<b>ADDRESSEES</b>	: Owners and operators of vehicles listed under "Application" ABC Customer Care and Parts Source
<b>VEHICLE MODEL</b>	: CX45, CX35, TX40, TX45, TD925US, TDX25US
<b>MANUAL CHAPTER</b>	: 9.6 Occupant protection system – Seat belts
<b>BULLETIN TYPE</b>	: Safety Recall (NHTSA 18V-209) (TC 2018-187)
<b>DATE</b>	: April 18 <sup>th</sup> , 2018
<b>SUBJECT</b>	: <b>To change rigid seat belt buckles of aisle side passenger seats</b>
<b>TERMS &amp; CONDITIONS</b>	: Refer to chapter "Warranty" further on in this bulletin.

Subject vehicles have passenger seats equipped with seat belt buckles of which the outer casing may fail. These casings are held in place by one plastic notch only. When subjected to great pressure (e.g. by standing on the buckle or tampering with the buckle), these casings may fail and consequently slide down, thereby uncovering the buckle mechanism. These buckles, as and when the covers have slid down, may give passengers the impression that the buckle mechanism is defective and as such inhibit passengers from buckling up. Van Hool has determined that the seat belt buckles at the aisle side are prone to this phenomenon due to the rigid fixation of these

**Figure 8**

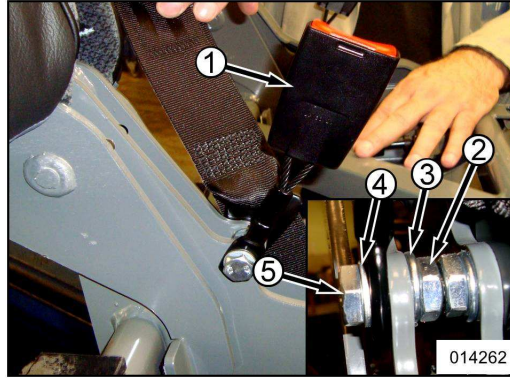
**In the middle of the seat frame,** install the new flexible seat belt buckle:

- a. Install flexible seat belt buckle 11568344 (1) by using screw 7/16" x 3/4" 20 UNF (5), washer (4), spring washer (3) and nut (2).
- b. Put the flexible seat belt buckle in the right direction and tighten the bolt to 22 ft.lbf (30 Nm).
